SERVICE BULLETIN

No. 623

Piper Aircraft Corporation

Diode Assembly Inspection,
(Circuit Breaker Cooler)

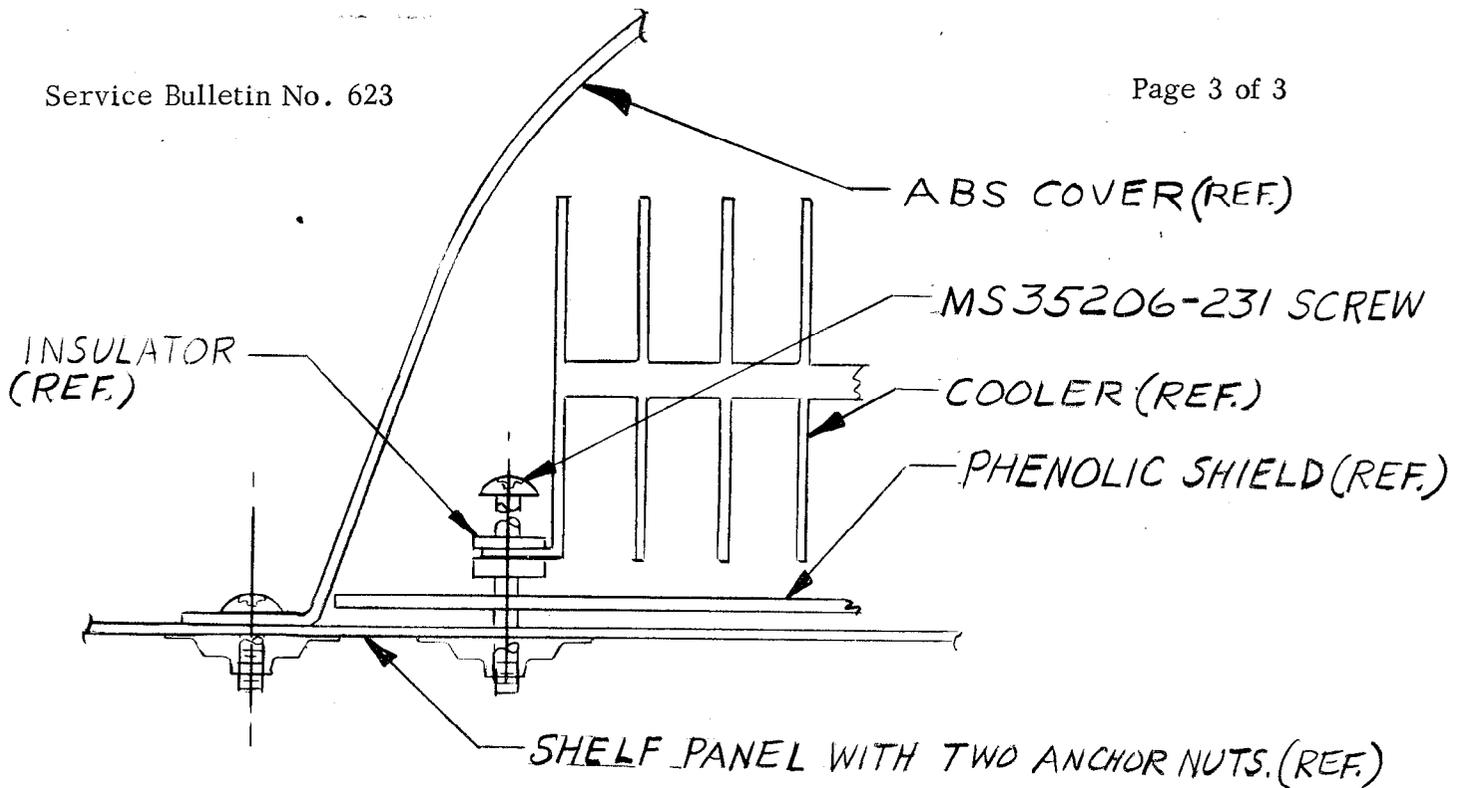
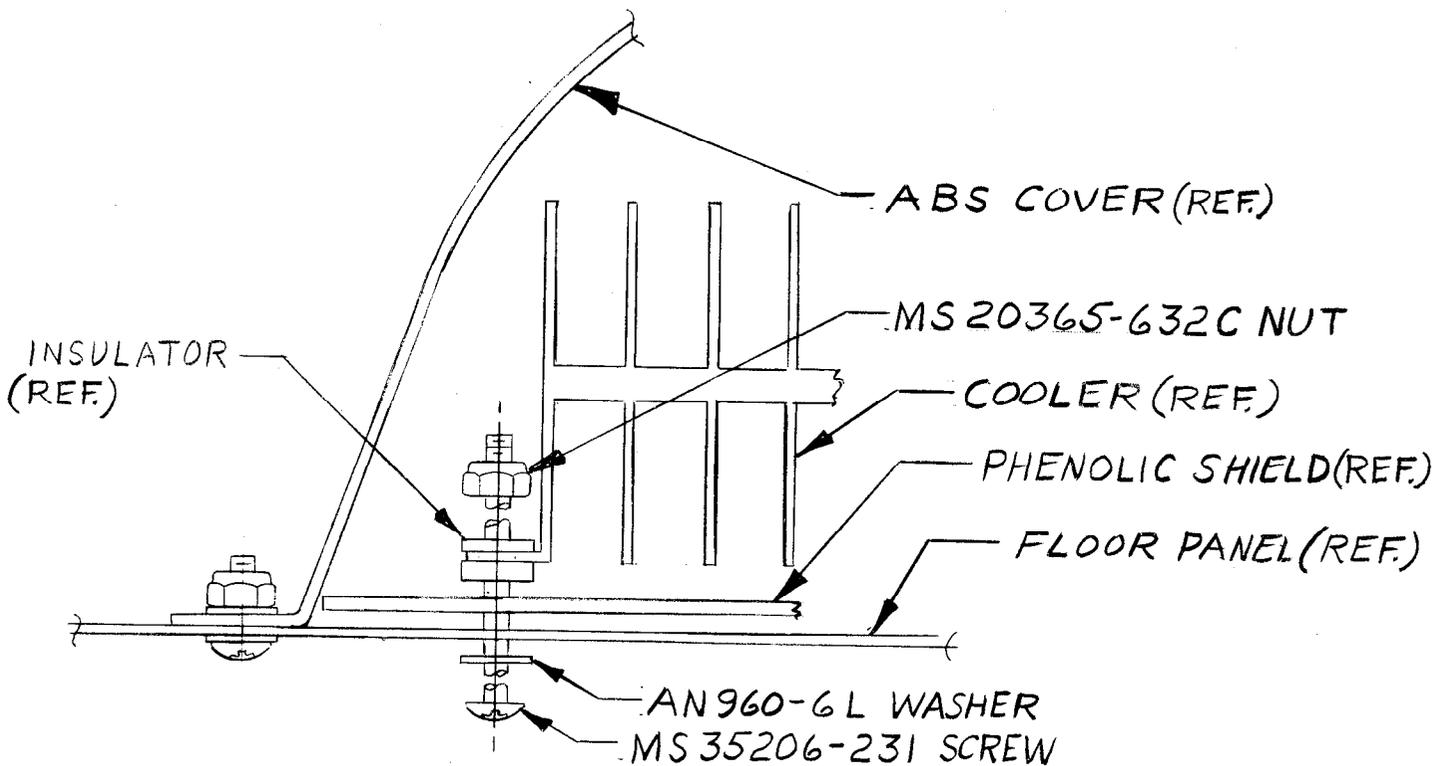
It has come to our attention that there may be an incorrectly installed washer (or washers) under the head of the screw(s) or the nut(s), depending on the model affected, which secure the diode assembly to the airframe. The washer(s) may intermittently come in contact with the diode assembly which would cause a temporary short circuit and demand maximum output from the alternator. This Service Release provides a sketch which indicates the correct hardware installation and instructions to remove any incorrectly installed washer(s) to prevent possible electrical system malfunction.

3. Inspect the four (4) screws securing the Diode Assembly to the airframe. Use the attached sketch to insure that there are no washers installed near the diode and that the Hardware is installed exactly as shown. If correct no further action is required. Proceed with Instruction 5.
4. If any washers are found under the screw head(s) or nut(s) installed incorrectly, they are to be removed and the screws reinstalled to secure the Diode assembly.
5. Reinstall the Cover-Diode Cooler if removed in Instruction Number 2 and reconnect the battery cables.
6. Make an appropriate log book entry that this Service Release has been complied with.
